RURAL MUNICIPALITY OF WEST RIVER  
RESOLUTIONS

MOTION #2021 -127

SCHEDULE A TO MOTION 2021-127

Re: Domes, PID: 219339-000

SCHEDULE A TO MOTION 2021-127 (CONTINUED)

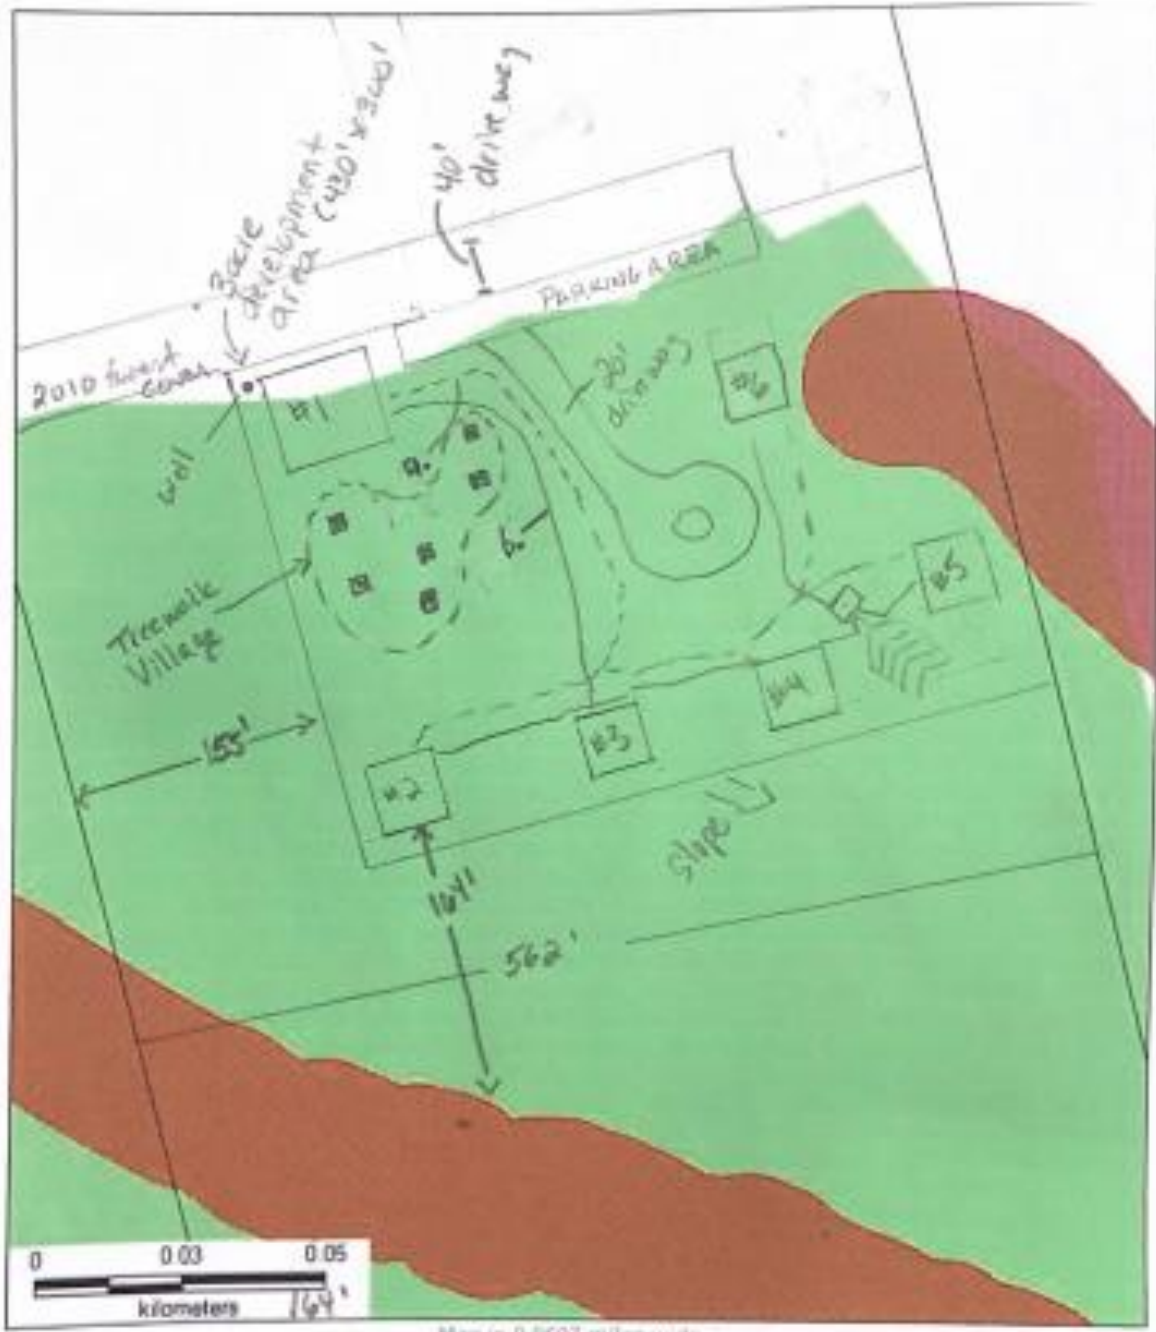
- A 30 ft. x 60 ft. building (Structure #1 as shown on Schedule “A”) containing an office, café, storage and washrooms;
- 5 Geodesic domes (as shown as structures 2 through 6 on Schedule “B”) as single unit tourist accommodation containing one bedroom, one bath and a kitchen on 40 ft. by 40 ft. platforms;

- All buildings and structures shall be located as shown on Schedule “A” and no closer than 20 feet to a property boundary;
- Parking shall be provided in the area shown on Schedule “A”;

- The driveway within the commercial area shall be a minimum of 20 feet in width and located as shown on Schedule “A”;
